PILGRIM WATCH

June 14, 2012

SUBJECT: Fukushima Lessons Learned Tier 3 Recommendations- Spent Fuel Pool vs. Dry Storage; Reliable Hardened Vents & Filtration of Containment Vents; Emergency Planning Issues, Expanding Size EPZ, Pre-staging Potassium Iodide Beyond 10 Miles, Monitoring; and Relegating Recommendations To Backfits

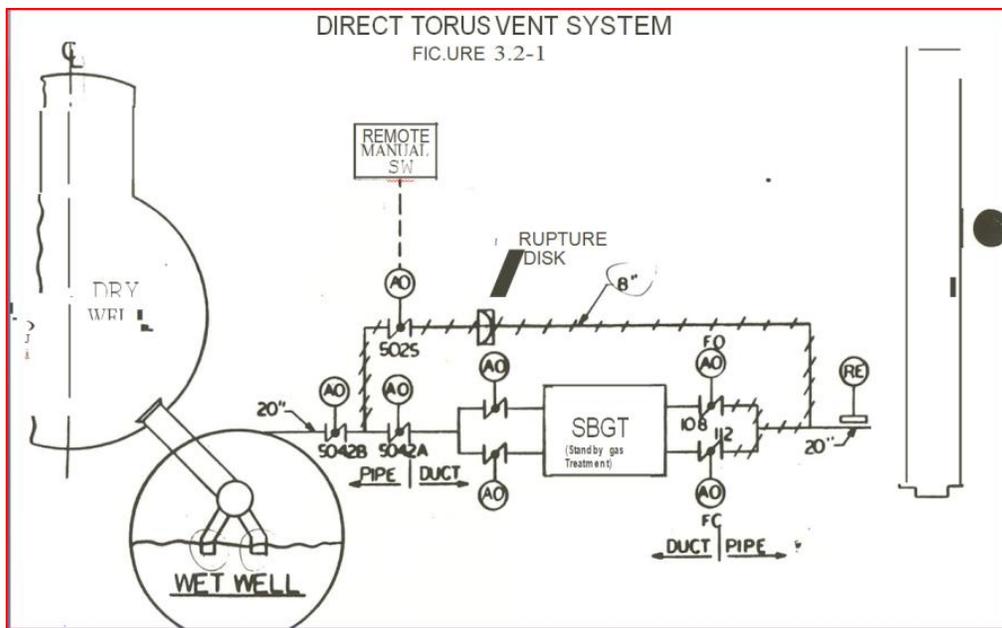
The DTVS provides a new 8" line branching off the existing torus purge exhaust line between the containment isolation valves (outside containment) with a reconnection to the existing torus purge exhaust line downstream of the SGTS. The new torus vent line is also provided with its own containment isolation valve and rupture disc, set to relieve at 30 psig.

The following diagram, that shows the branch line with its own containment isolation valve 5025 and Rupture Disc, is included in the attachment to BECO's letter. It will be noted that the Rupture Disc is downstream of valves AO-5042B and AO-5025, and that both of these valves are normally closed and are designed to be opened either remotely from the control room or manually.²⁰

- An 8” butterfly valve (AO-5025), which can be remotely operated from the control room, is added downstream of 8” valve AO-5052B. This valve acts as the primary containment outboard isolation valve for the DTV line. Test connections are provided upstream and downstream of AO-5025.

- AO-5042B was replaced in 1988 with a DC solenoid valve (powered from essential 125 volt DC) so that it would operate without dependence on AC power. AO-5025 is also provided with a DC solenoid powered from a redundant 125 volt DC source. Both valves are normally closed and are closed in a “fail-safe” position. One inch nitrogen lines are added to provide nitrogen to valves AO-5042B and AO-5025.

- A rupture disc is included in the piping to provide a second leakage barrier. It is designed to open below containment design pressure, but will remain intact up to pressures equal to or greater than those which cause automatic containment isolation during accident conditions.
